New Albany Architectural Review Board
Monday, June 8, 2026 Meeting Minutes - DRAFT

ARB-36-2026 6905 Central College Road New Build Certificate of Appropriateness and Waivers

ARB-37-2026 Upper East Rooftop Modifications Certificate of Appropriateness

ARB-38-2026 Harvest Pizza Certificate of Appropriateness

Image: Proposed site layout, showing the buildings, pavement and parking, and general landscaping.

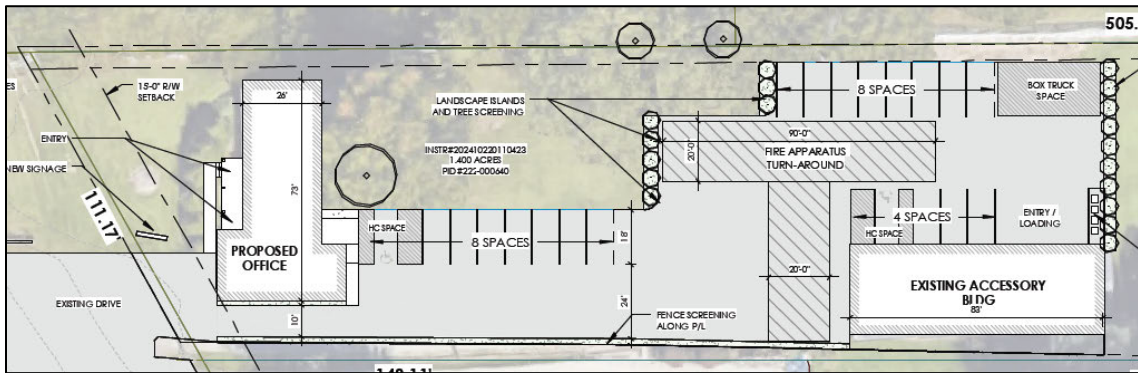
4. The distance of the pavement from the southern lot line is unclear. Staff recommends a condition of approval that the parking lot pavement be at least five feet away from the southern property line (condition #1).
5. **Lot coverage:** The zoning text permits a maximum lot coverage of 80 percent, which includes both buildings and pavement. The applicant is proposing a lot coverage of approximately 42 percent. The requirement is being met.

6. A Traffic Access Study will be completed for Planning Commission review.
7. As required for commercial developments by the Urban Center Code (see UCC evaluation below), staff recommends a condition of approval that a bike rack be installed on the site, subject to staff approval (condition #2).

Image: Axonometric sketch from the City Architect depicting the proposed garage relative to the main entry mass.

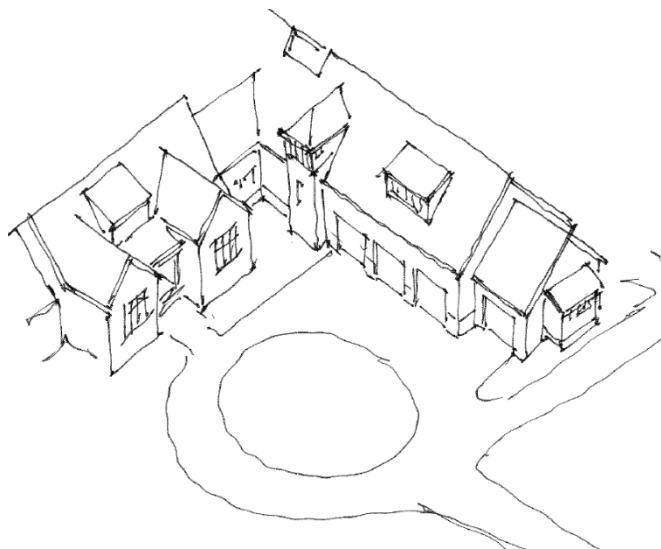
- The applicant proposes a new home with a large garage mass extending approximately 55 feet from the main portion of the home toward the public right-of-way. The garage mass includes four garage doors that face the eastern side yard and are not front facing, though they are in front of the main portion of the house. The garage mass appears to be approximately 30 feet in height and is one of only a few portions of the house with a second-story dwelling area.
- DGR Section 1(I)(E) states that parking areas and garages should be placed in locations to minimize their visual impact through a combination of garage location and landscaping or other screening methods. It further states that garage doors should not be on primary façades

of buildings. Similarly, the Engage New Albany Strategic Plan encourages rear or side-loaded garages, and when a garage faces the street, the front façade of the garage should be set back from the front façade of the house (Engage New Albany, p. 60).

- The waiver does not meet the intent of the standard or the goals of other city regulations. The garage doors technically do not face the primary road as recommended by the DGRs and Strategic Plan; however, the garage form and location do not minimize the visual impact of the garage. If the garage mass were to be integrated into the rest of the home or scaled down rather than essentially standing alone from the rest of the building, it may better fit with the goals of the DGRs. At a minimum, the height of the garage mass should be decreased.

Building B - Proposed

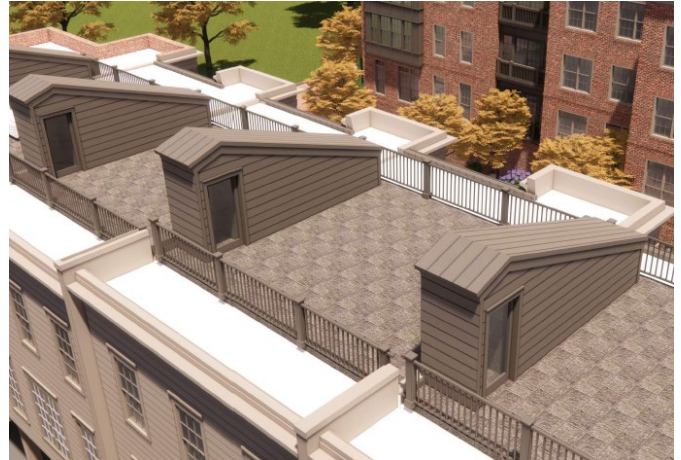
Board Member Davie remarked that with the skylight version it makes sense to repeat it, but with a pop up on the left it might make sense to mirror rather than having them all on the same side. As proposed they look like fingers. He further remarked that this feels like the solution to a problem and lacks cohesiveness, it does not feel like an impressive solution.

The applicant is requesting modifications to the townhome building (Building B, as shown on the site plan below), including the removal of skylights, elimination of half-height privacy walls between units, and the incorporation of rooftop garden access structures.

The City Architect reviewed the proposed revisions, including the removal of the skylights and addition of the rooftop garden access structure, and expressed no concerns with the changes. The modifications will have minimal impact on street views while significantly improving functionality and access for future occupants.

Staff have no concerns with the proposed revisions, as the modifications have been thoughtfully integrated into the overall building design to limit their visibility from adjacent streets and nearby properties. The architectural treatment and finish materials are consistent with the existing upper-story façade, helping the additions blend seamlessly with the structure. The revised design also creates a more cohesive screening element between rooftop garden areas while enhancing usability and access for residents.

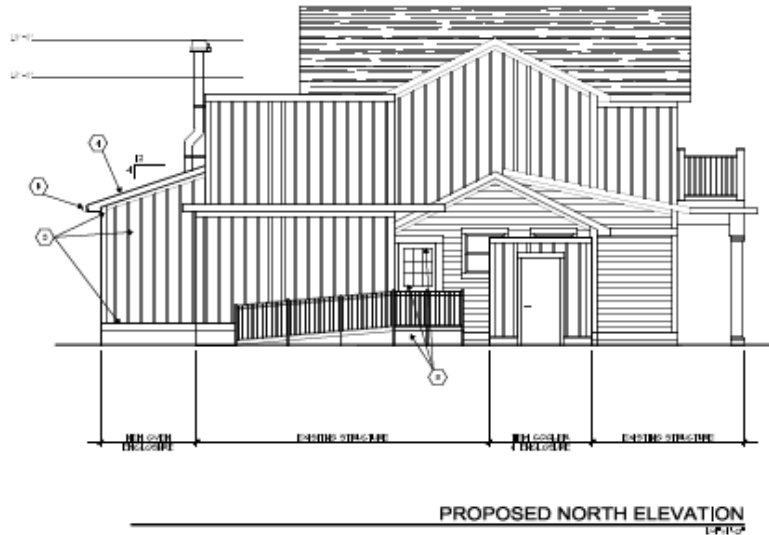
- The applicant proposes the following exterior changes to the building and site:
 - A new pizza oven enclosure.
 - A new detached cooler and enclosure.
- The oven enclosure is proposed to include a ventilated pipe that extends slightly below the highest point of the primary structure's roofline. In addition to the oven enclosure, the applicant proposes relocating the patio ingress/egress slightly to the east to accommodate the addition.

- The cooler enclosure is proposed to be detached and located next to the existing ramp on the north side of the building, and will have the same building materials as the existing structure on site.

- It appears that all of the proposed exterior building modifications appropriately relate to the original ARB approval through the use of the same Hardi board siding material, roof, trim, and details. While the applicant proposes to replace the double French doors on the east elevation, there are still two building entrances along this elevation.
